XLamp® XR-E LED Product Change Notification

PCN Reference Number: CreeLED-PCN-5234
Date Issued: June 3, 2022

The following graph shows the improved Forward Voltage vs. Current curve.

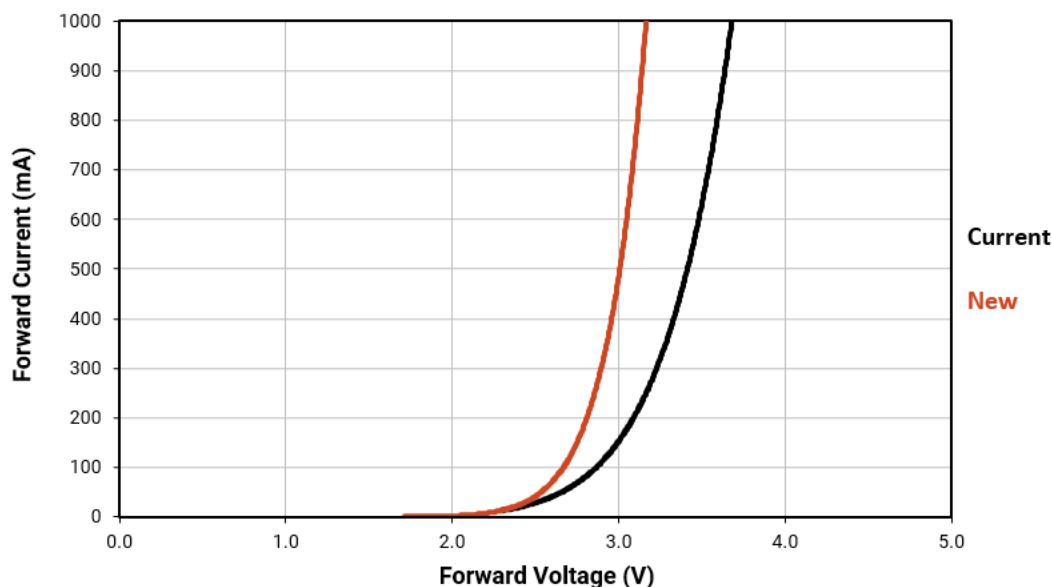
Cree LED will be changing the typical thermal resistance, typical and maximum forward voltage, and typical temperature coefficient of voltage characteristics for the affected XR-E LEDs. Table 2 shows the current and new values.

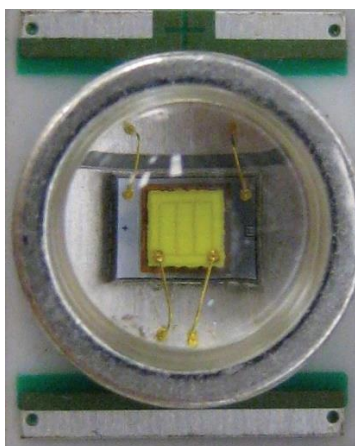
The visual appearance of the LED will change. Examples of the current and new visual appearances are shown below.

Current Appearance

New Appearance
